A12 Chelmsford to A120 widening scheme

TR010060

9.53 Written submission of oral case for Issue Specific Hearing 3

Written submission of oral case for Issue Specific Hearing 3

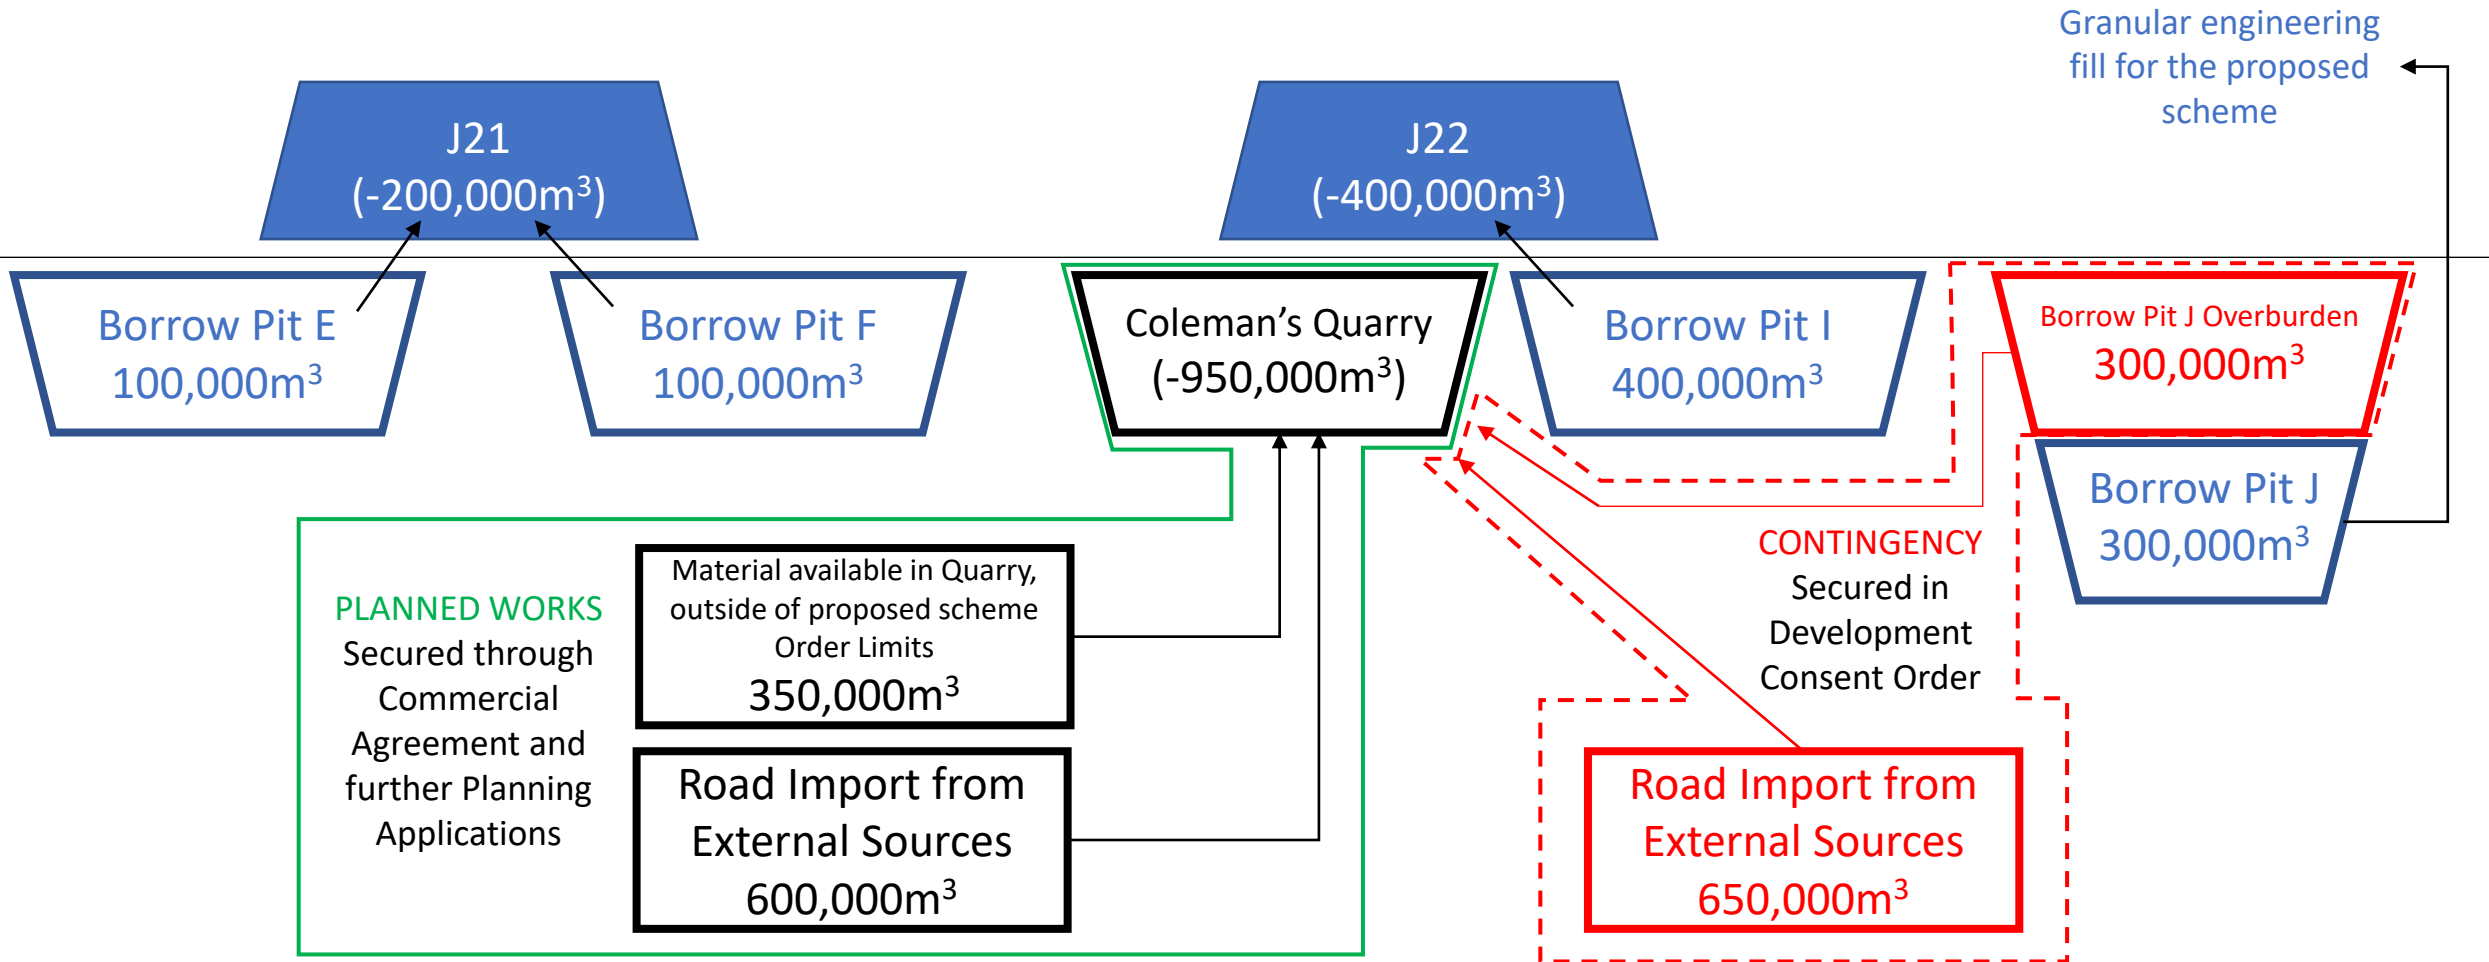
Ref:	Comment/ Representation by:	Questions/Issues Raised at the ISH3	Applicant's Response
			<p>The impact during construction of the proposed scheme on the setting of the moated site at Marks Tey Hall (Asset 818) has been assessed to be of minor magnitude on an asset of high value, leading to an adverse effect of moderate significance. Taking the mitigation measures proposed for construction impacts into account, the residual significance of effect was assessed to be slight, and therefore there is no change to the conclusions presented in Appendix 7.9: Cultural Heritage Impact Assessment Summary Tables [APP-117] of the Environmental Statement.</p> <p>There would be no physical impact on the scheduled monument during construction of the proposed scheme, and therefore there would be no impact on its evidential value. Realignment of the junction between Hall Chase and the A12 would have a slight effect on the setting of the monument when considered in plan, although it would not affect the ability to understand the relationship between the monument and the main road.</p> <p><i>Operation effects</i></p> <p>Permanent lighting is proposed for the new roundabout and realigned section of Hall Chase. This would be provided by embedded mitigation in the form of light-emitting diode luminaires designed to reduce light spill into adjacent areas, as described in Paragraph 2.5.71 of Chapter 2: The Proposed Scheme [APP-069]. The impact of lighting would be further reduced by filtering from the mature vegetation surrounding the Marks Tey Hall farm group. This vegetation falls outside of the Order Limits and would therefore be retained.</p> <p>Retention of the mature vegetation surrounding the moated site and Marks Tey Hall Farm would screen views in, and out of, the site, as can</p>

Ref:	Comment/ Representation by:	Questions/Issues Raised at the ISH3	Applicant's Response
			<p>be seen in the photomontage from Viewpoint 24 on Figure 8.5 of the Environmental Statement [APP-220]. Screening would be further enhanced by proposed woodland planting around the acoustic bund west of Hall Chase, and individual tree planting adjacent to the realigned section of Hall Chase and hedgerow and intermittent tree planting south of the proposed attenuation pond once mature (shown on sheet 18 of the Environmental Masterplan, part 3 [APP-088]).</p> <p>Changes in noise near the asset during operation are predicted to be in the region of +0.1 to +0.9dB (see noise change plans in Figure 12.8 of the Environmental Statement, sheet 11 [APP-235]). This change would not be perceptible in the context of the existing setting of the asset. The effects of noise from traffic using the realigned section of the A12 would be reduced by the proposed acoustic bund south of Hall Chase, and the use of road surfacing with better noise reducing properties than a conventional low noise road surface. These measures would be secured through Commitments LV2 and NV10 of the REAC [APP185].</p> <p>The impact during operation of the proposed scheme on the moated site at Marks Tey Hall (Asset 818) has been assessed to be of negligible magnitude on an asset of high value, leading to an adverse effect of slight significance. Because the setting of the asset would not be identical to its state before construction of the proposed scheme, the residual significance of effect was also assessed to be slight, and therefore there is no change to the conclusions presented in Appendix 7.9: Cultural Heritage Impact Assessment Summary Tables [APP-117] of the Environmental Statement.</p> <p>Summary</p> <p>The moated site at Marks Tey Hall (Asset 818), and the associated</p>

Ref:	Comment/ Representation by:	Questions/Issues Raised at the ISH3	Applicant's Response
			<p>group of listed buildings comprising Marks Tey Hall (Asset 819), the Barn north-west of Marks Tey Hall (Asset 817), and Marks Tey Hall south barn (Asset 816) are all designated heritage assets, assessed to be of high value for their significant archaeological, architectural and historic interest, and their group value as the descendants of a high-status medieval farm.</p> <p>The setting of the monument is formed of two parts. The group of buildings and the moated site have an inward-facing setting defined by their proximity to one another, and the mature trees both within and surrounding the farm which isolate them visually from their surroundings. The site also has a wider setting formed by its geographical position as an island surrounded by farmland, connected to a main road by a single access route.</p> <p>Construction and operation of the proposed scheme would introduce new elements of infrastructure into the wider setting of Marks Tey Hall farm and create noise and visual impacts on the asset. Despite the changes to the alignment of the A12 and Hall Chase, it would still be possible to appreciate the setting of the moated site at Marks Tey Hall, its relationship with the listed buildings within it and the farmland and main road beyond, and its contribution to its significance. Although a greater residual significance of effect was assessed on the setting of the individual listed buildings, the applicant contends that the proposed scheme would not affect the ability to appreciate the significance of the medieval moated site, the contribution of the listed buildings to its setting, or the contribution of its setting to its significance during construction or operation.</p> <p>The predicted impacts of operation of the proposed scheme on the setting of the scheduled monument would not affect the evidential or historic value of the monument.</p>
